**Case File Number: ER030004, DA13171, PUD13170-PUDF-01 and -02      February 22, 2017**

<b>Location:</b>	<b>Jack London Square Development Project: Sites D at Broadway and F2 at Harrison Street (south of Embarcadero, APN 018 041500101).</b>
<b>Proposal:</b>	Final Development Permits for Sites D and F2.
<b>Applicant:</b>	CIM Group, Sean Buran: p: (323) 860-1811
<b>Owner:</b>	CIM Group
<b>Planning Permits Required:</b>	Final Development Permits.
<b>General Plan:</b>	Site D=Retail, Dining and Entertainment-1; and Site F2=Waterfront Commercial Recreation-1.
<b>Zoning:</b>	C-45 Community Shopping Commercial Zone
<b>Environmental Determination:</b>	Final EIR certified on March 17, 2004 by the Planning Commission; Addendum #1 approved on September 23, 2014.
<b>Historic Status:</b>	None for affected sites.
<b>Service Delivery District:</b>	I – Downtown/West Oakland/Harbor
<b>City Council District:</b>	3 – Lynette Gibson McElhaney
<b>Action to be Taken:</b>	Conduct design review of proposed FDPs

# CITY OF OAKLAND PLANNING COMMISSION

**NORTH (EMBARCADERO) ELEVATION**  
**FINAL DEVELOPMENT PLAN**  
 Jack London Square - Parcel D  
 CIM Group

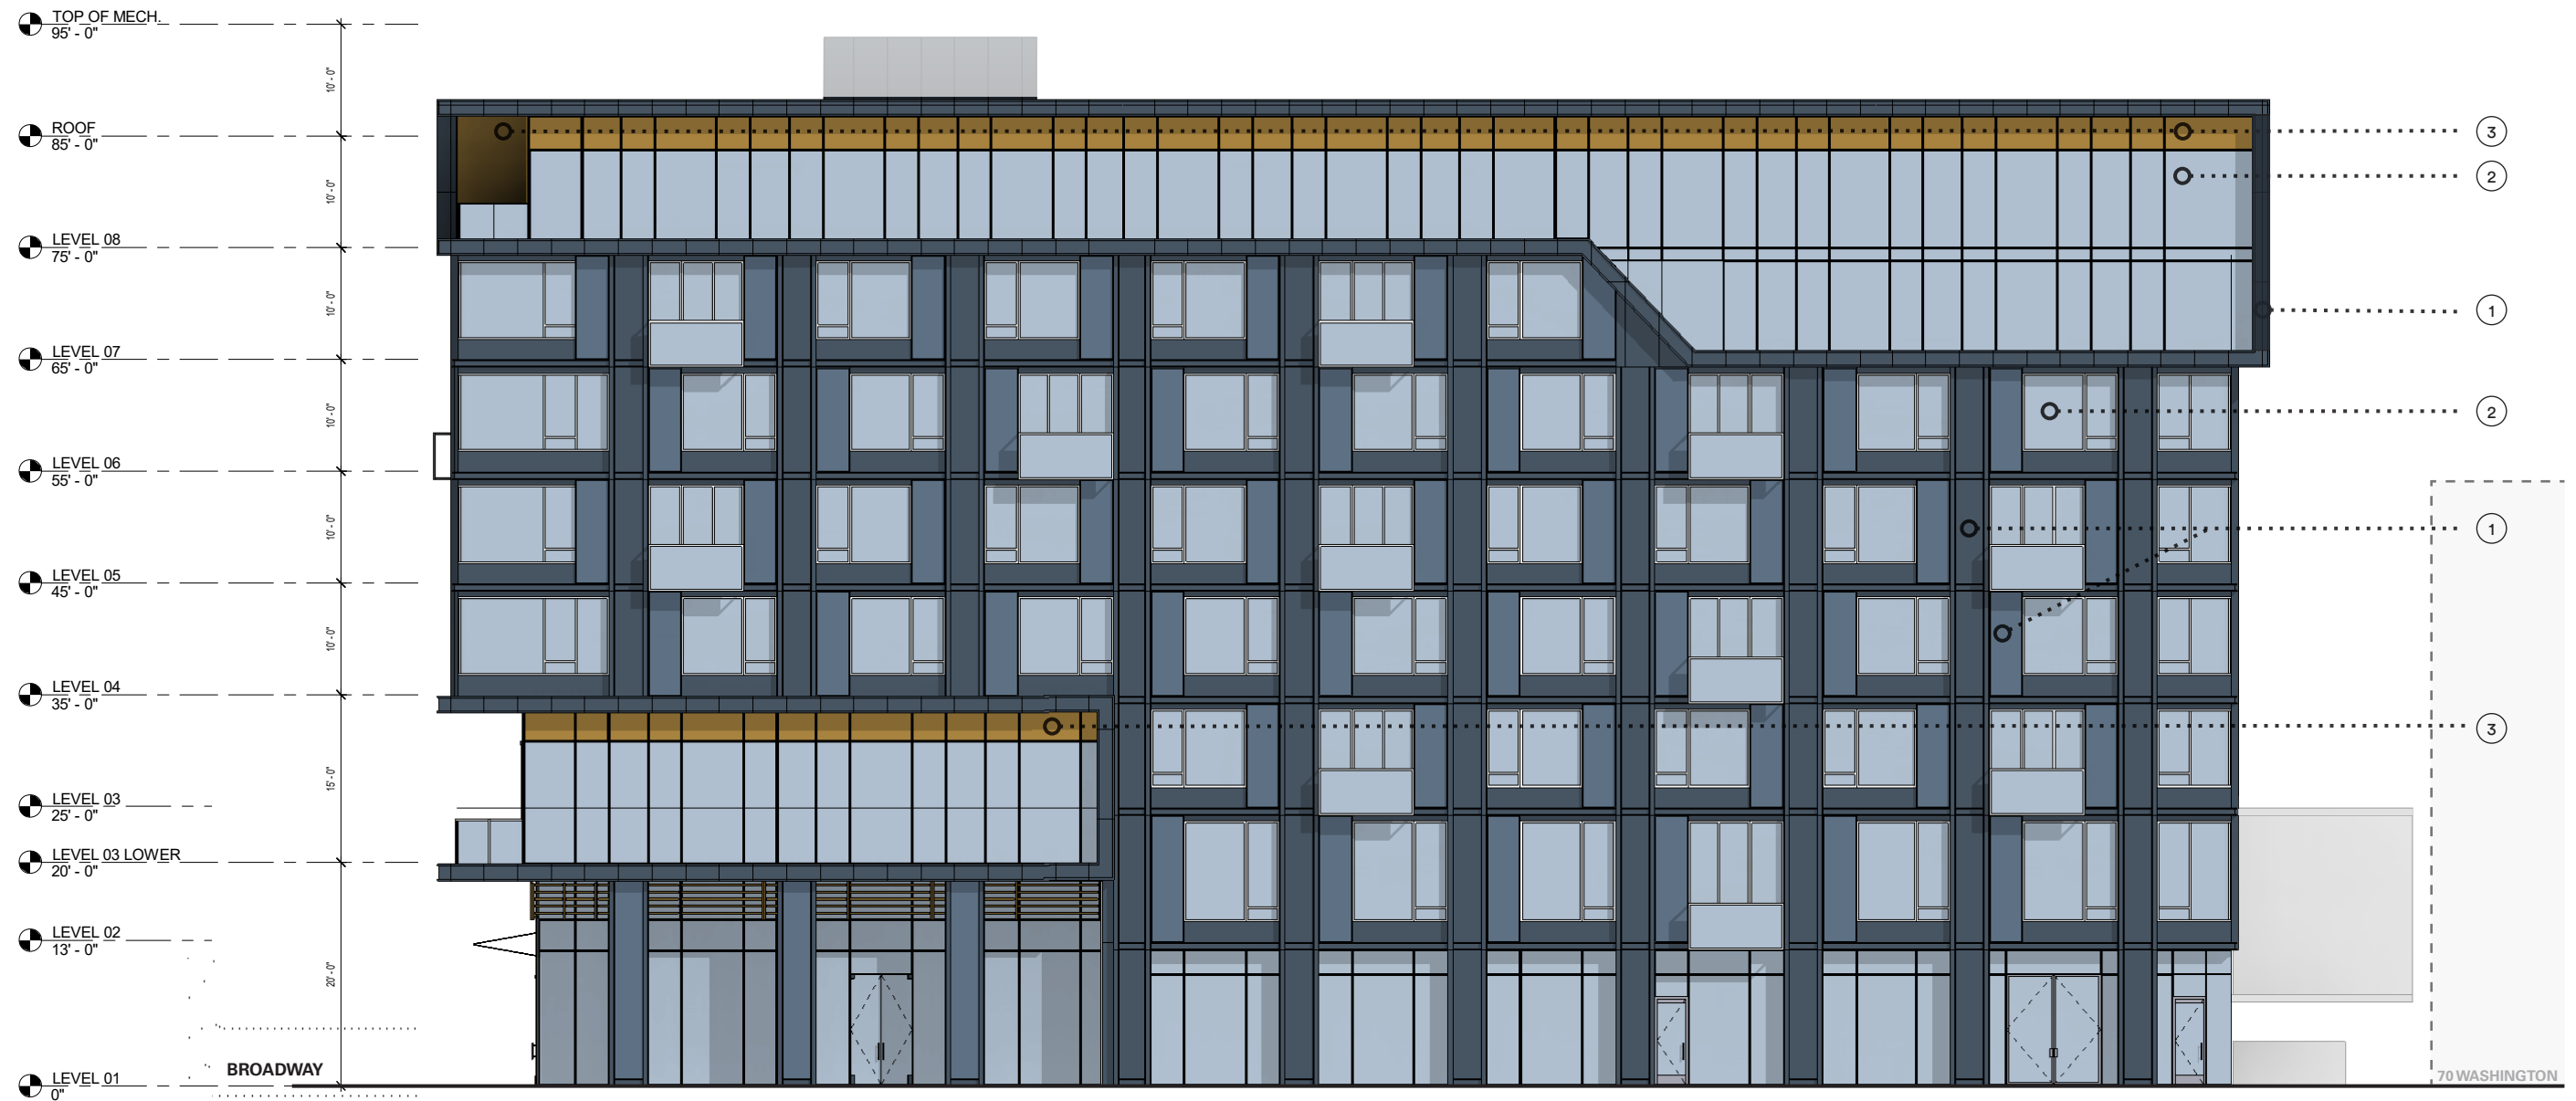
The D site is well-designed with a dynamic roof line, dramatic soffit detailing and large expanses of glazing. However, the dark base color of the building is cool and recedes into the background. The D site is a gateway site in Oakland. The building at that site should have a signature, welcoming color scheme that reflects its location on the Oakland waterfront and near the Port of Oakland.
